Access Compliance Report Public Rights-of-Way (Curb Ramps)

Intersection ID: 44216Main Street:ROZZELLES_FERRY_RDCross Street:ROZZELLES_LANDING_DRLocation:NWADA ID: 84B2D7400861Ramp Type:PerpInitial Pass/Fail:FailOverall Compliance:NoSeverity Score:35

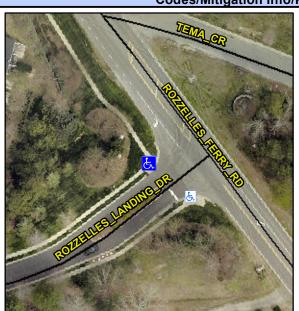
russible sululiuli			
Possible Solutions:	<u>c</u>		
Remove & Replace Entire Ramp.			
	N		
	N		
	N		
	N		
	N		
Surveyor Notes:	N		
N/A	N		
	N		
	N		
	N		
PROW/ADA:	N		
R304.5.1, R304.2.2, R304.5.3	N		
	N		
	N

Field Measurements/Component Compliance						
Comp	liance Description	Data	Comp	liance Description	Data	
N/A	Ramp Length (in)	50.0	No	Ramp Slope (%)	12.9	
No	Ramp Width (in)	40.0	No	Ramp XSlope (%)	4.5	
N/A	Flare Type LT	N/A	N/A	Flare Type RT	N/A	
N/A	Flare Slope LT (%)	N/A	N/A	Flare Slope RT (%)	N/A	
N/A	Flare Traversable LT?	N/A	N/A	Flare Traversable RT?	N/A	
N/A	Landing Length (in)	N/A	N/A	DWS Provided?	N/A	
N/A	Landing Width (in)	N/A	N/A	DWS Contrast?	N/A	
N/A	Landing Slope (%)	N/A	N/A	DWS Length (in)	N/A	
N/A	Landing X Slope (%)	N/A	N/A	DWS Full Width?	N/A	
N/A	Landing Curb? (Y/N)	N/A	N/A	DWS Offset (in)	N/A	
N/A	Shared Landing?	N/A				
N/A	Gutter Ponding?	N/A	N/A	Gutter Slope (%)	N/A	
N/A	Gutter Lip Ht (in)	N/A	N/A	Gutter X Slope (%)	N/A	
N/A	Painted X Walk1?	No	N/A	Painted X Walk2?	N/A	
	X Walk 1 Direction	To SE		X Walk 2 Direction	N/A	
N/A	X Walk 1 Width (in)	N/A	N/A	X Walk 2 Width (in)	N/A	
	X Walk 1 Slope (%)	2.0		X Walk 2 Slope (%)	N/A

X Walk 1 X Slope (%)	3.2		X Walk 2 X Slope (%)	N/A	
N/A	Ramp inside XWalk1?	N/A	N/A	Ramp inside XWalk2?	N/A	
	Road Slope (%)	N/A	N/A	Clear Space?	N/A	
	Road X Slope (%)	N/A	N/A	Clear Space to XWalk (in)	N/A	
N/A	Any Obstructions?	N/A	N/A	Storm Grate/Utility Hazard?	N/A	
	Obstruction Type			Storm Grate/Utility Type		
		N/A			N/A	
			Yes	Surface Condition? (G/P)	Good	
the fact of
